MONTGOMERY COUNTY HISTORIC PRESERVATION COMMISSION
STAFF REPORT

Address:	7323 Takoma Ave., Takoma Park	Meeting Date:	9/19/18
Resource:	Outstanding Resource Takoma Park Historic District	Report Date:	9/12/18
Applicant:	Jane and Andrew Spalding	Public Notice:	9/5/18
Review:	HAWP	Tax Credit:	n/a
Case Number:	37/03-18JJJ	Staff:	Dan Bruechert
Proposal:	Rear Addition Construction and Installation of Mechanical Equipment

1 PROPOSED EAST ELEVATION
 A9 1/4" = 1'-0"

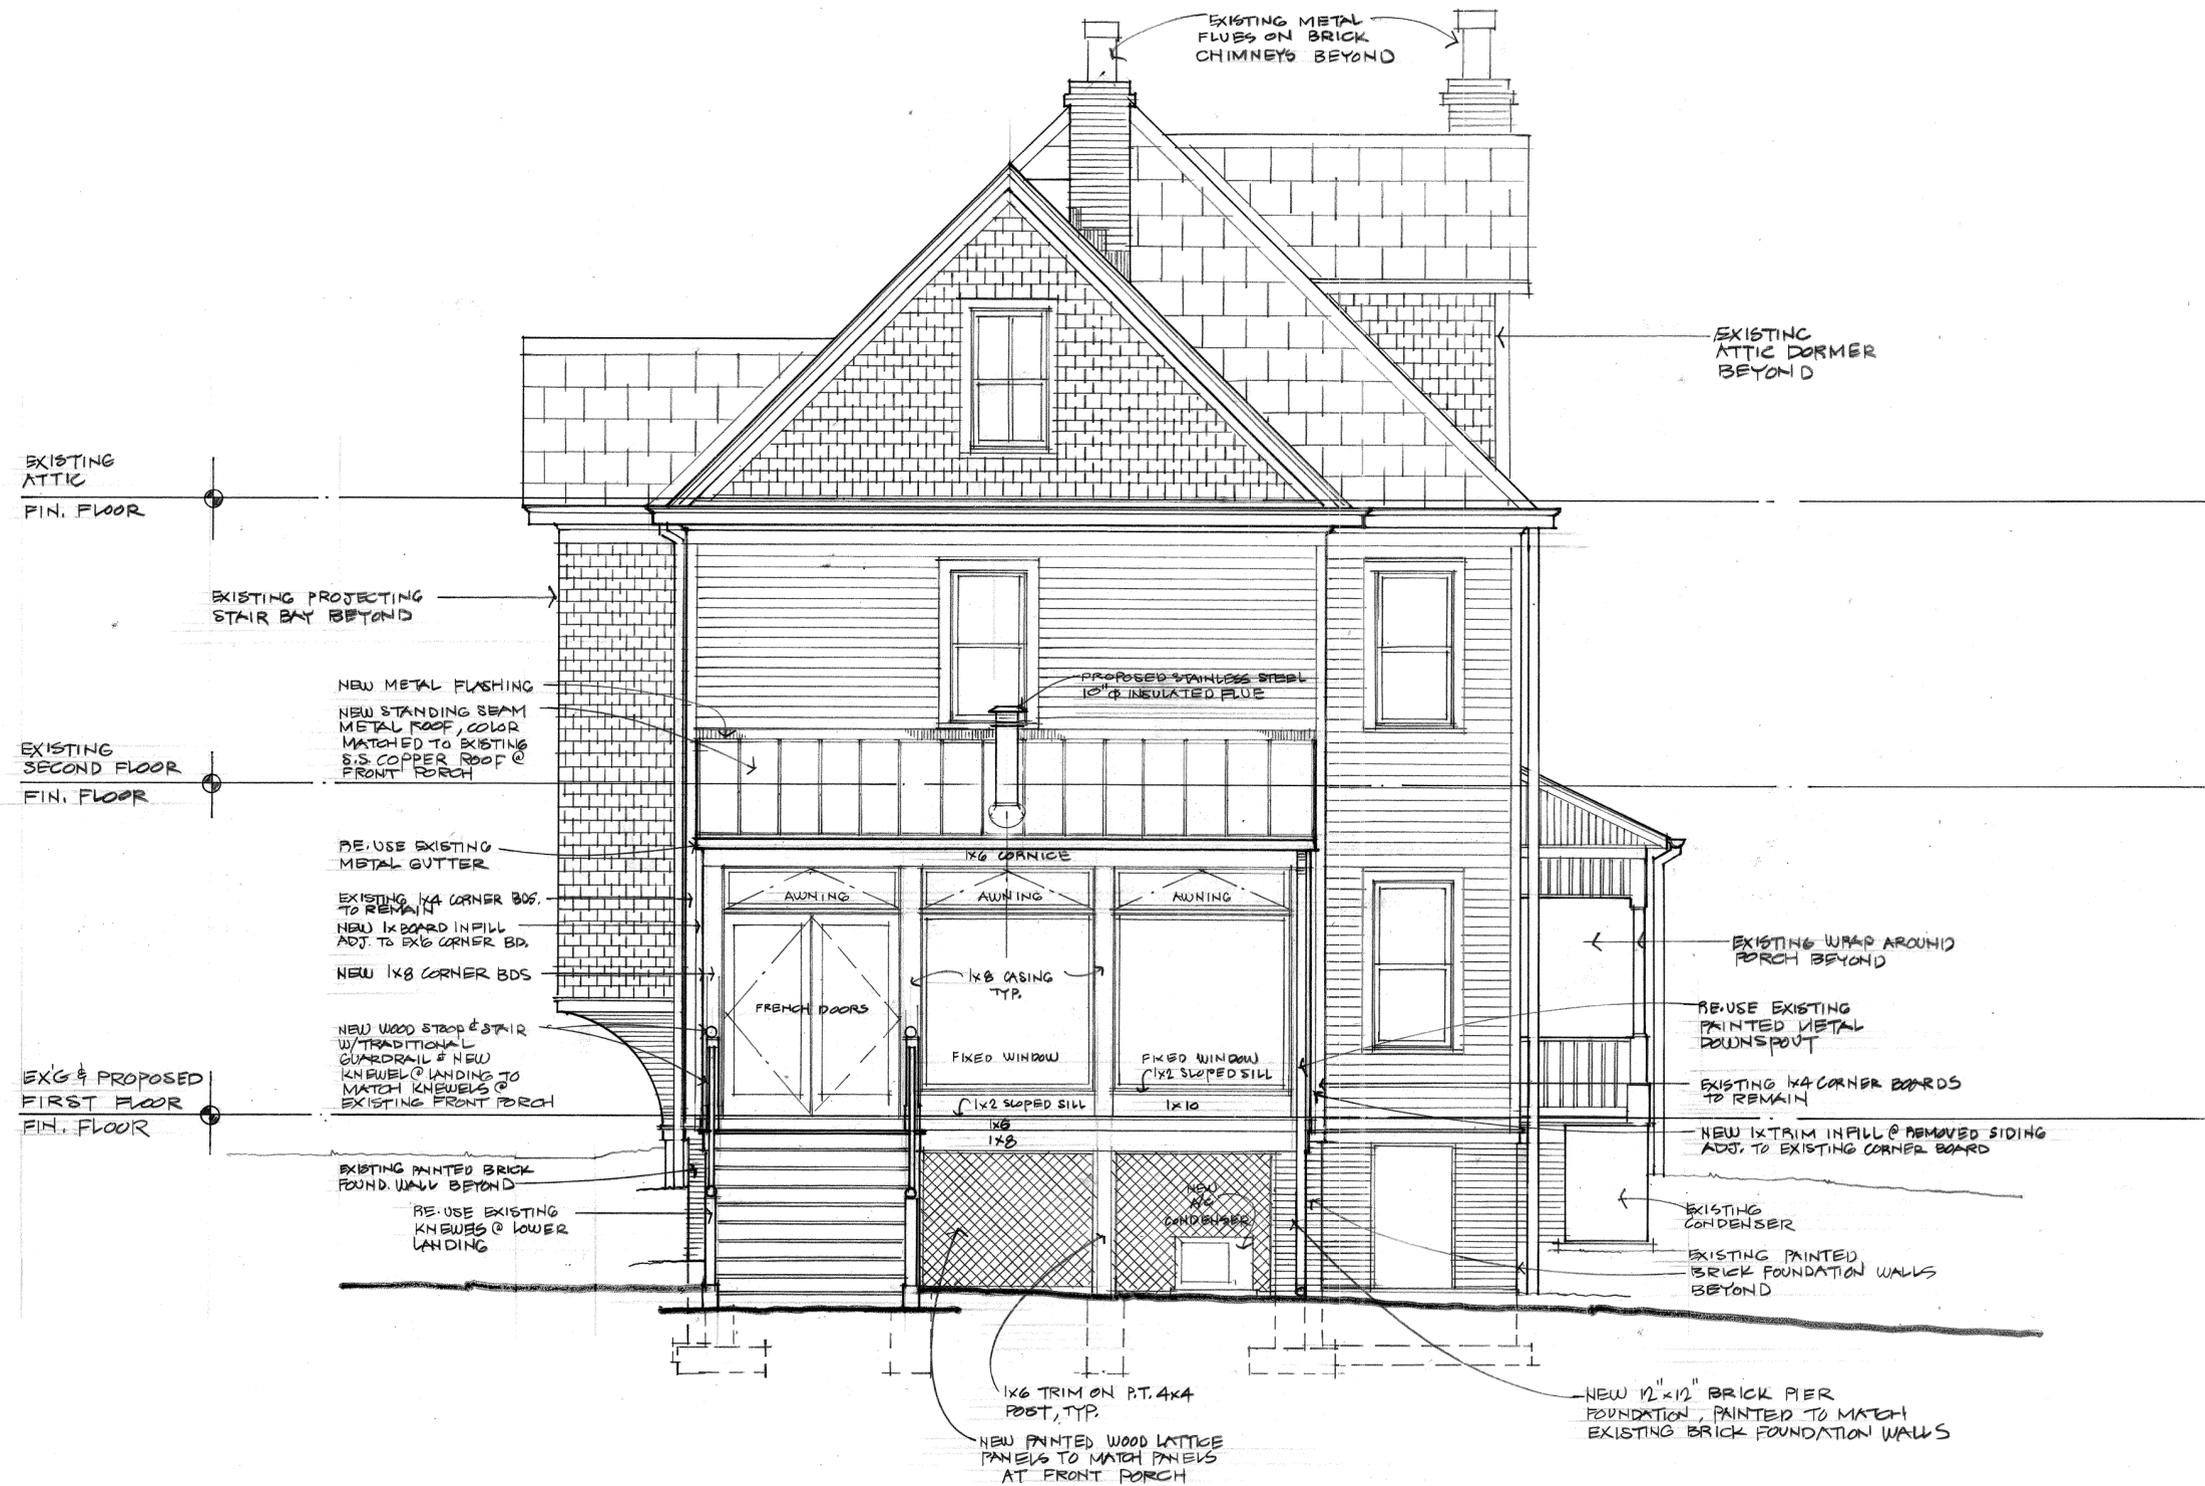
The fenestration pattern for the addition has been revised from the preliminary submission and now reflects a consistent approach, utilizing large fixed windows with awning transom windows above. All of the openings are separated by 8" (eight inch) casing. The south (right) elevation is divided into thirds with three windows. The north (left) elevation is also divided into thirds, with two window assemblies in the left and center openings and clapboard siding in the right opening. The clapboard infill is used because there are new mechanical systems installed into the wall. Because of the façade steps back on this side, this portion of the addition will not likely be visible from the public right-of-way. The east (rear) elevation is also divided into thirds, with a pair of French doors to the left and evenly sized openings in middle and right openings. To the rear of the addition the applicant proposes constructing a new wood staircase with a small landing at the top.

In the Staff Report for the Preliminary Consultation, Staff was concerned that there may be too much glass to be compatible with the historic resource and surrounding district. The HPC, however, indicated that more glazing would be preferable so that the new construction visually read like an enclosed rear porch. The HPC further supported that the design of the addition be revised to reinforce the vertical orientation, consistent with the Queen Ann design of the historic house. Staff finds that the revised design satisfies the recommended revisions. The applicant has introduced more glazing with fewer separations to create an appearance consistent with an enclosed porch. And by removing the lower fixed window from the design eliminated a horizontal element and emphasizes the vertical members.
